Review of EPRI cost data

Review of EPRI new entrant generation cost data for use
within Energy White paper modelling

Prepared for AEMO/DRET

March 2010

Figure 1 Comparison of non-renewable technology capital costs

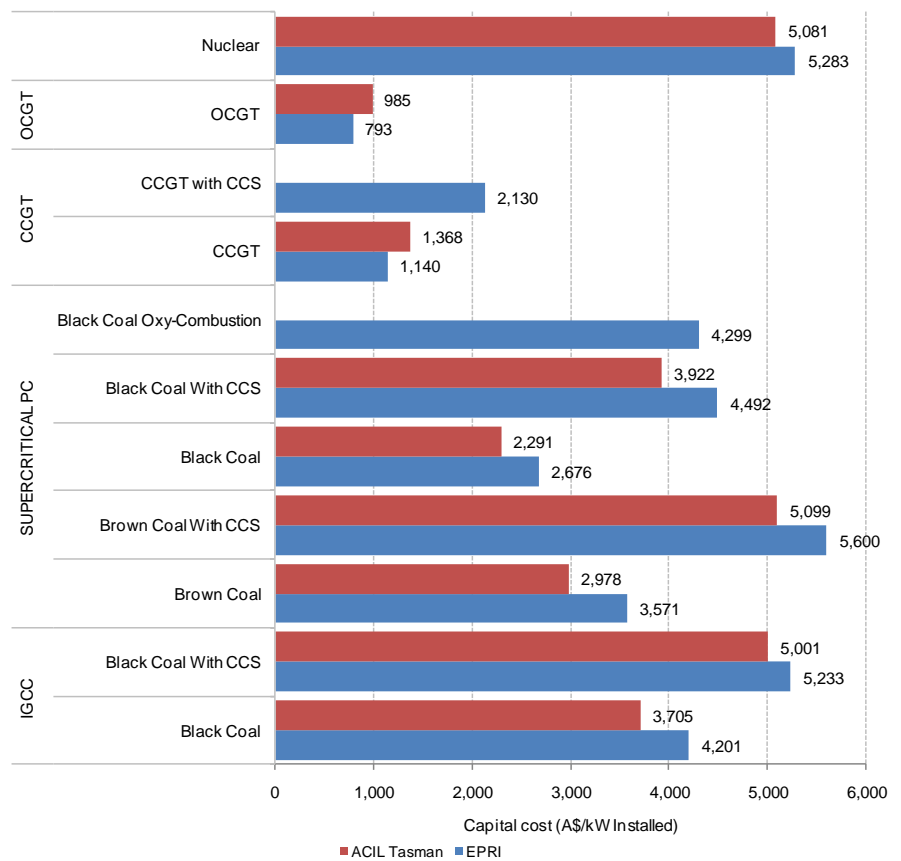
Figure 1 compares EPRI and published estimates from ACIL Tasman for technology capital costs, expressed in A\$/kW installed. ACIL Tasman has not previously published estimates for CCGT with CCS or Oxy-combustion black coal and hence, no comparative estimate is provided.

ACIL Tasman recommends the EPRI estimates for other non-renewable technologies be adopted as given.

Figure 2 Comparison of non-renewable capital costs with EPRI ranges (A\$/kW installed)

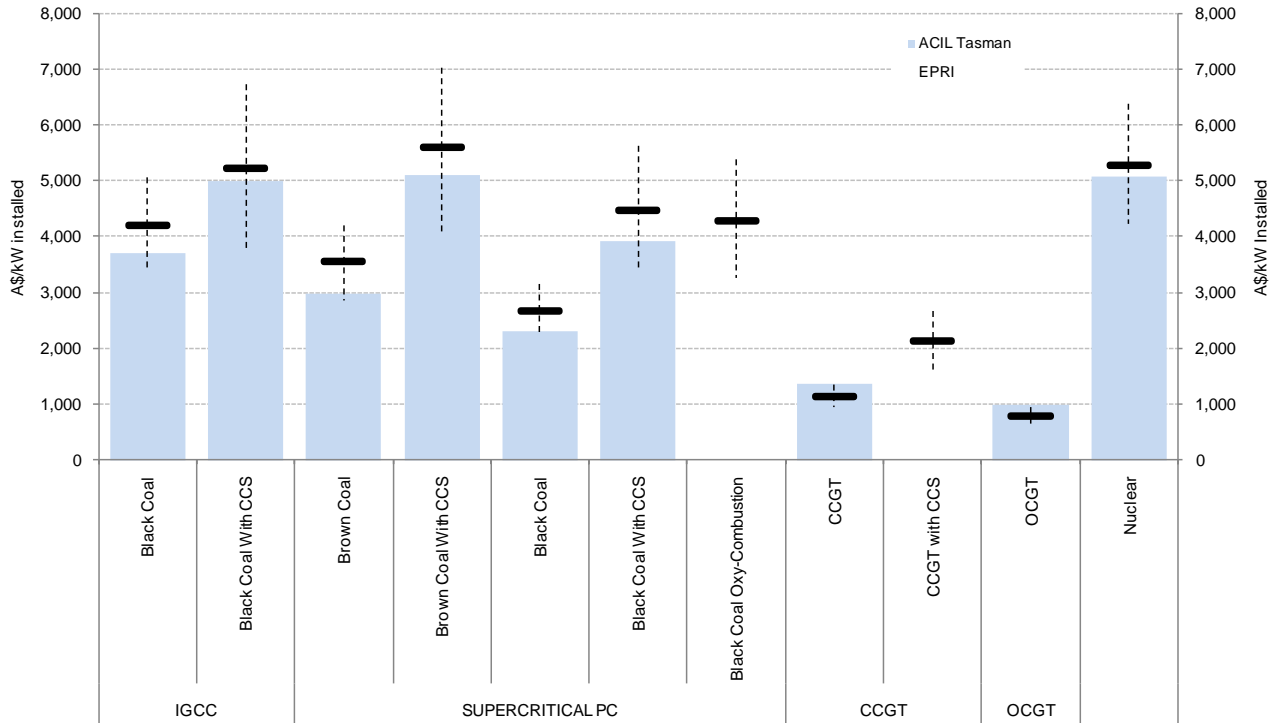
Figure 2 shows an alternative view of the capital cost comparisons and also includes the 'high' and 'low' ranges on the EPRI figures. In all cases the ACIL Tasman estimates falls within the EPRI range of uncertainty however there are some key differences:

- For CCGT and OCGT gas-based technologies ACIL Tasman estimates lie in the extreme upper end of the EPRI estimates. We have been unable to determine the exact reason for this difference but believe this may relate to inherent differences within the 50Hz and 60Hz markets for turbines. ACIL Tasman has access to recent project costs in Australia and has also discussed costs with proponents who have recently constructed these units, reaffirming ACIL views. ACIL Tasman believes the EPRI figures are somewhat low relative to Australian market conditions, albeit still within the +/- 30% accuracy range.

- Upon review of supercritical brown coal costs, ACIL Tasman has concluded that the EPRI estimates are reasonable and that the original ACIL Tasman estimates (published for the IRPC) were too low relative to black coal plant of the same type. While there have been no brown coal developments for around 15 years in Australia, a premium of around 30% can be expected over the comparable black coal plant. ACIL Tasman recommends that the EPRI brown coal figures be adopted.

Table 2 summarises the proposed changes for capital costs. Changes are proposed for gas-based technologies (CCGT and OCGT) and by implication, CCGT technology that employs CCS.

Figure 3 **Comparison of renewable technology capital costs**

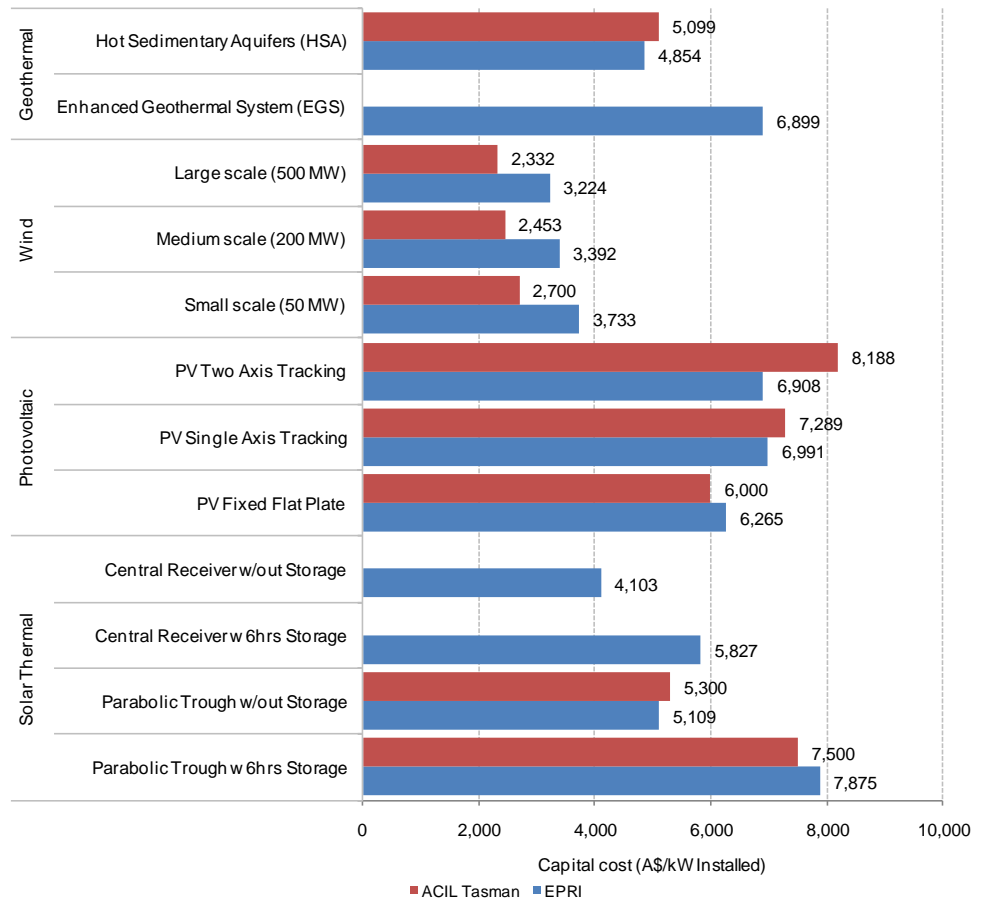
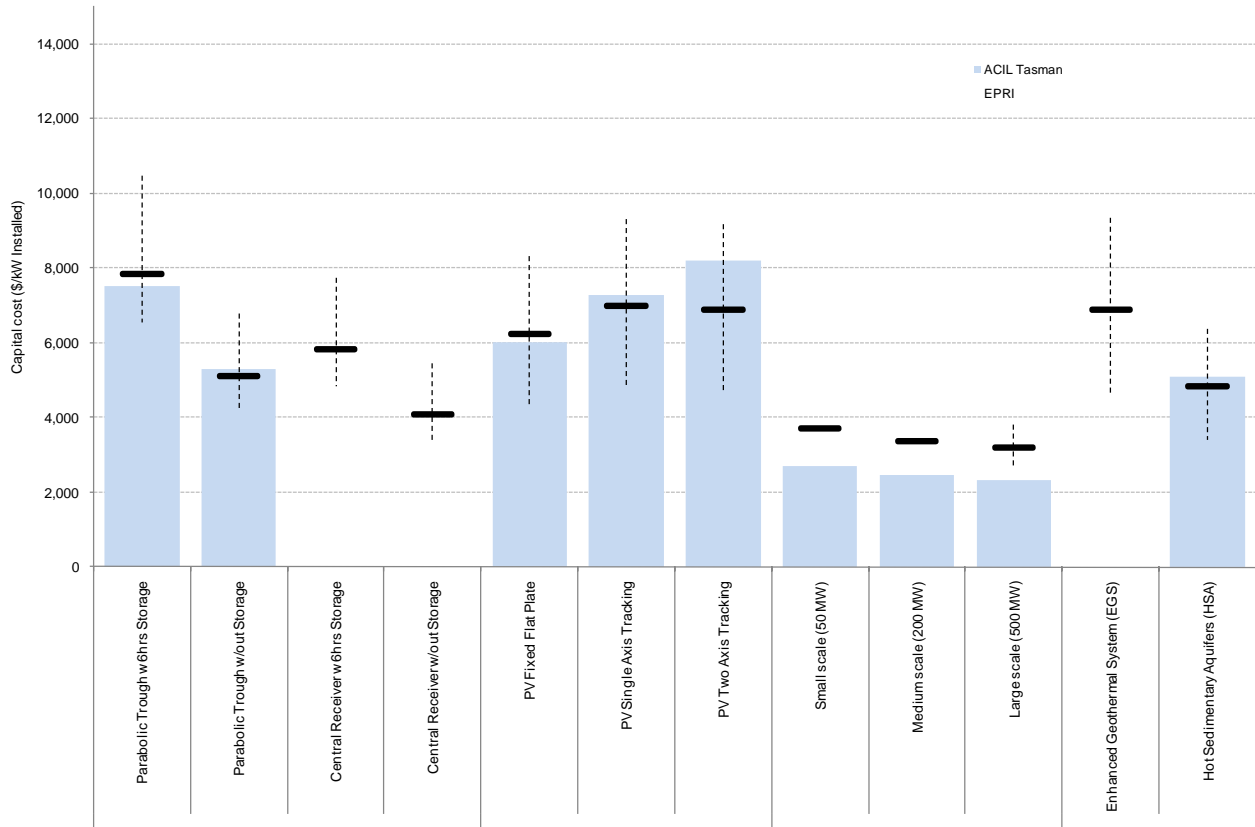
The ACIL Tasman and EPRI values are reasonably close for all technologies with the exception of wind.

For wind turbines EPRI appear to have based its cost estimates upon high-end 'intelligent' turbines which include a number of power system features not commonly installed in Australia. These turbines include models from GE, Enercon and REPower. In Australia, wind turbines installed to-date have generally been lower cost Vestas or Suzlon machines (as detailed in Table 5) that generally do not incorporate these more sophisticated features.

Based on actual wind project costs to-date and discussions with wind proponents within Australia, ACIL Tasman recommended the use of a lower capital cost figure than EPRI's estimate. Even with the transition to meet increases licensing requirements ACIL Tasman does not expect installed wind turbine costs to reach levels suggested by EPRI.

ACIL Tasman has some recent experience with parabolic trough proponents in Australia in response to the Government's Solar Flagship program. Costs estimates are reasonably close to EPRI's figures and it is recommended these are adopted.

ACIL Tasman does not have any detailed cost data on solar thermal central receiver technology but has significant doubts whether this offers lower capital costs relative to parabolic trough designs. However, in the absence of other data, ACIL Tasman recommends the EPRI estimate should be adopted.

The figures adopted by the AEMO and DRET in consultation with the Stakeholder Reference Group for wind lie roughly in the middle between the EPRI and ACIL Tasman estimates.

AEMO/DRET have adopted a lower capital cost than both EPRI and ACIL Tasman for solar photovoltaic based on feedback from the Stakeholder Reference Group.

Figure 5 **Comparison of total operation and maintenance costs**

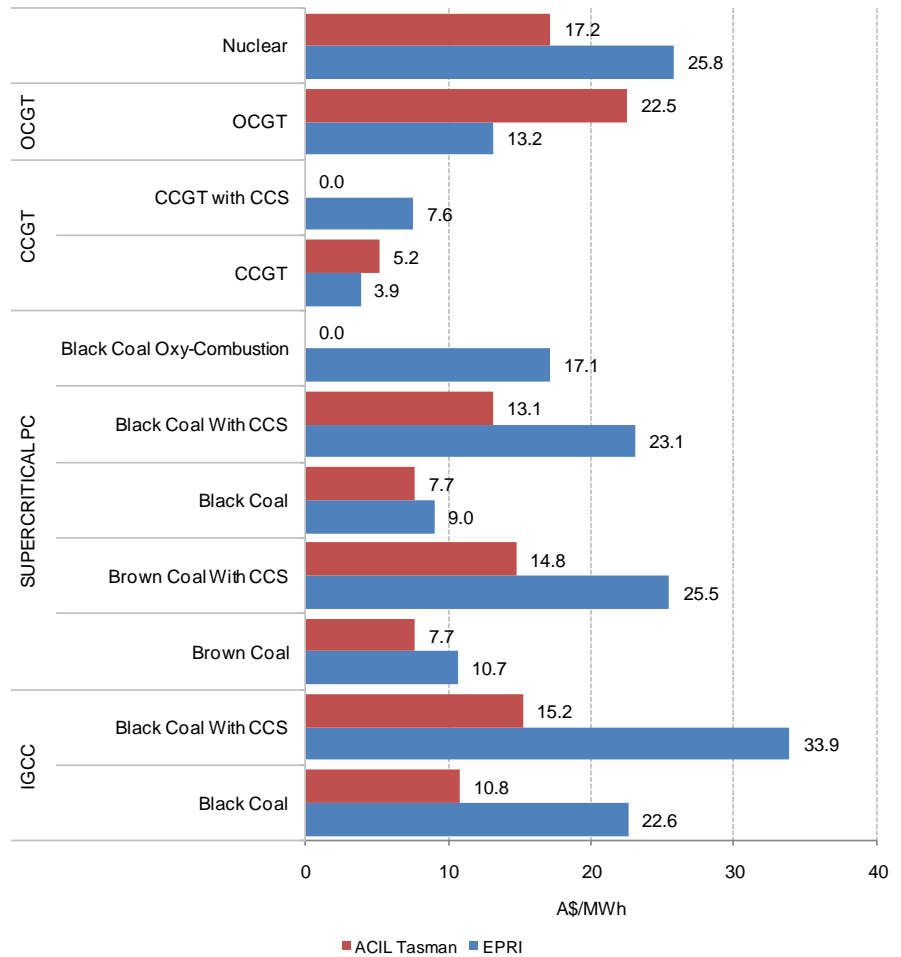
Table 9 summaries the total O&M costs. AEMO/DRET adopted the EPRI numbers having regard to the views of the Stakeholder Reference Group. ACIL Tasman note that EPRI’s O&M figures are generally higher across the board, however the large differences are generally for emerging technologies for which there is little (if any) actual Australian data to refer to.

Figure 6 **Comparison of renewable fixed operation and maintenance costs**

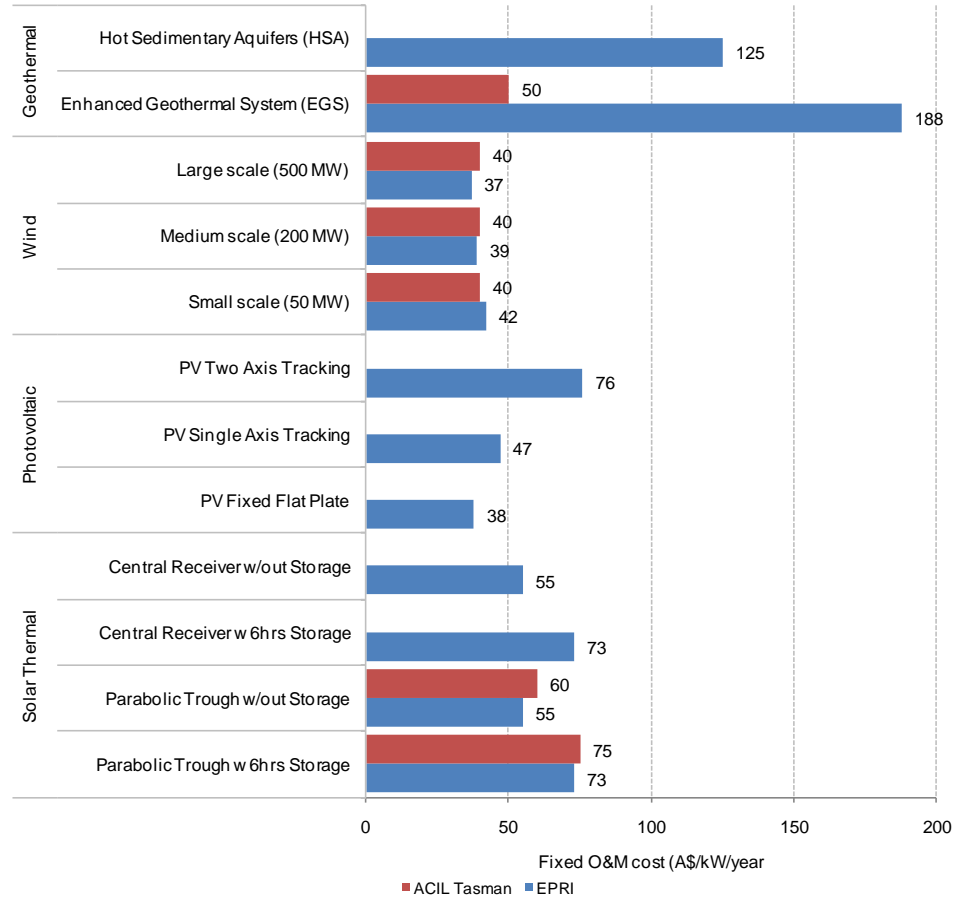
Figure 6 compares FOM costs for renewable technologies. For those technologies for which ACIL Tasman has historically undertaken estimates, there is good alignment with the EPRI figures. The only exception is in relation to geothermal technologies where there is significant uncertainty given that we do not have any operational plants at this stage.

EPRI and ACIL Tasman FOM estimates as well as values adopted by the Stakeholder Reference Group are detailed in Table 10. The Stakeholder Reference Group made relatively minor adjustments to EPRI values based on changes to capital cost estimates for these technologies.

Figure 7 Comparison of thermal efficiency estimates (sent-out % HHV)

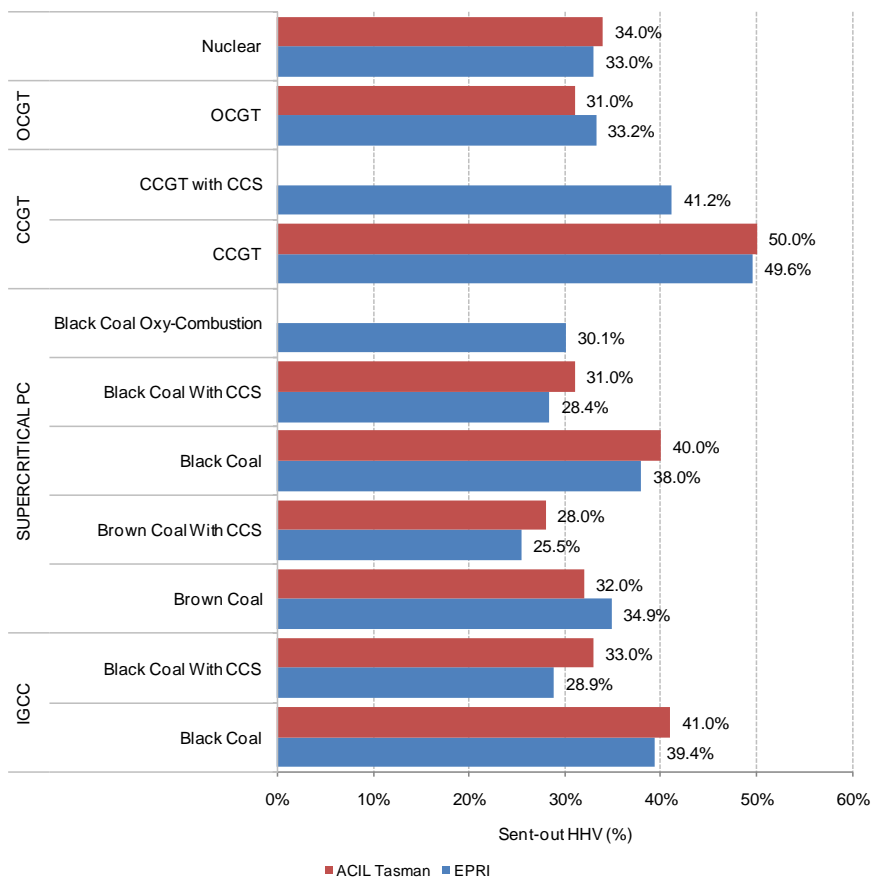
Figure 7 shows a comparison of EPRI and ACIL Tasman thermal efficiency assumptions across the non-renewable technologies examined. In general the estimates are closely aligned with no major divergence in views. For technologies where ACIL Tasman does not have a published estimate available, the EPRI estimate appears reasonable.

AEMO/DRET have adopted the EPRI thermal efficiency figures for all technologies for 2015 and 2030.

Figure 8 Comparison of station auxiliary use

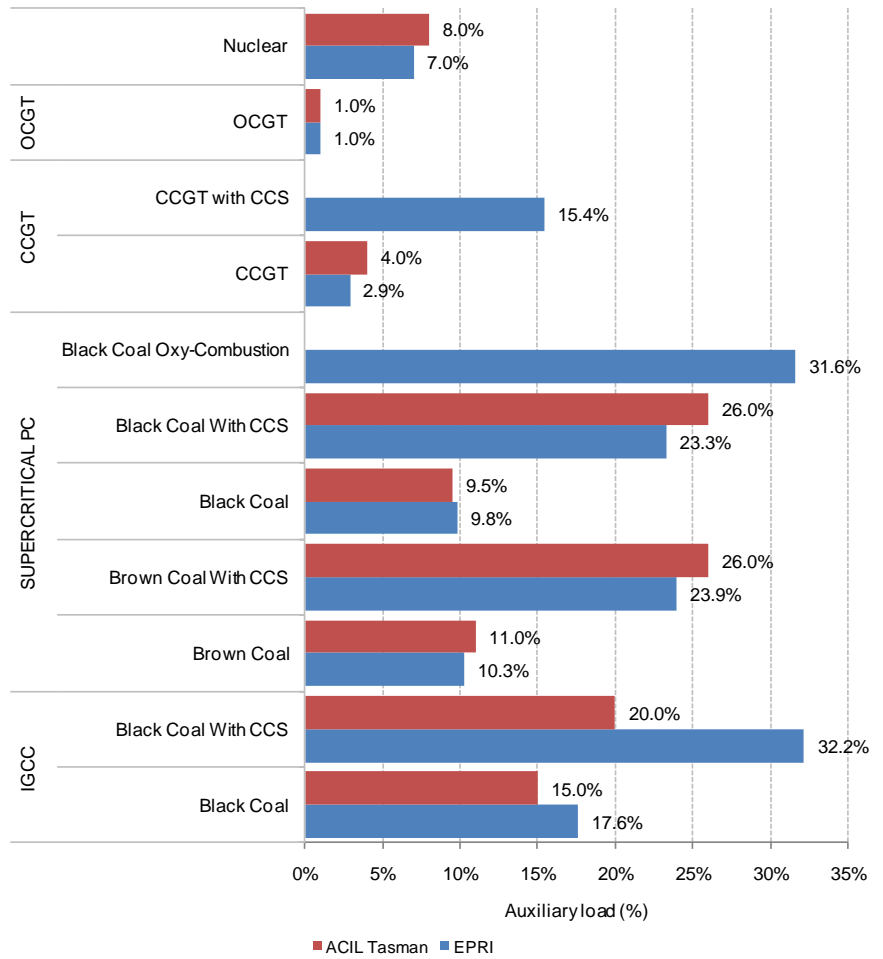
Figure 8 compares ACIL Tasman and EPRI estimates for auxiliary use across the non-renewable technologies. In general there is good alignment between the datasets, with the exception of CCS equipped ICGG plant.

In relation to CCS equipped IGCC, the EPRI estimate for auxiliary usage appears high. While stripping CO₂ from the syngas stream results in a reduction in thermal efficiency it does not (to the best of ACIL Tasman's knowledge) result in a significant increase in auxiliary use. The water-gas shift reactor is an exothermic reaction (i.e. it gives off heat) and will require more syngas to be produced as the energy contained within the syngas has been reduced. As mentioned by EPRI within its report, some of this heat can be utilised within the plant to generate high pressure steam which will offset to some extent this loss in efficiency.

As far as ACIL Tasman is aware, the only major additional internal electrical load from the addition of CO₂ stripping to IGCC plants is in relation to CO₂ compression prior to pipeline transport. Other generation cost studies indicate that an increase to IGCC auxiliary use of around 9.5% is required to capture 90% of CO₂ emissions (IGCC auxiliaries without capture being around 16%, and with capture being around 25.4%).⁵

For this reason, ACIL Tasman has suggested an amendment the auxiliary estimate for CCS equipped IGCC black coal plant as detailed in Table 14. These adjustments have taken into account in the values adopted by AEMO/DRET while all other EPRI estimates for auxiliaries have been adopted as given.

Figure 9 **Comparison of emission intensity estimates**

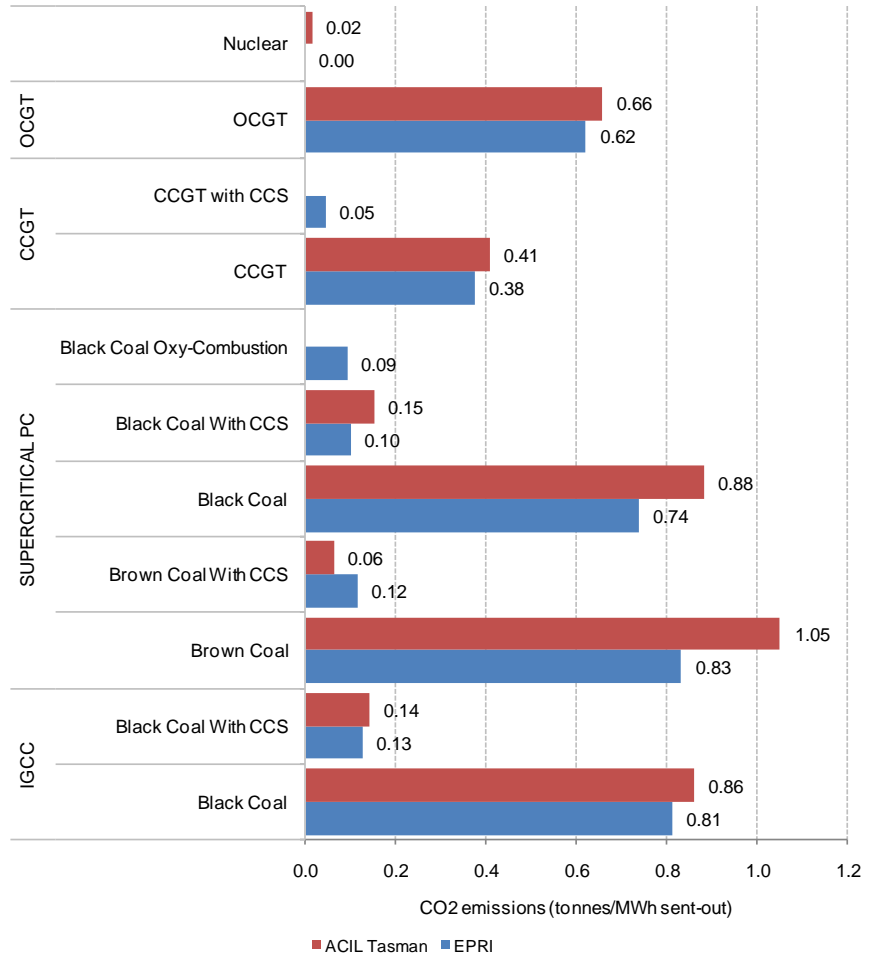
Figure 9 provides a comparison of EPRI and ACIL Tasman emission intensity figures for non-renewable technologies. In general, ACIL Tasman's figures are slightly higher than EPRI's as a result of the inclusion of fugitive emissions with the ACIL Tasman numbers. Capture rates for CCS equipped plant are broadly similar between the two estimates.

As emission intensity is a derived figure rather than a direct input, these comparisons are made for information only. Any changes to these figures would be effected via changes to thermal efficiency or emission factors.
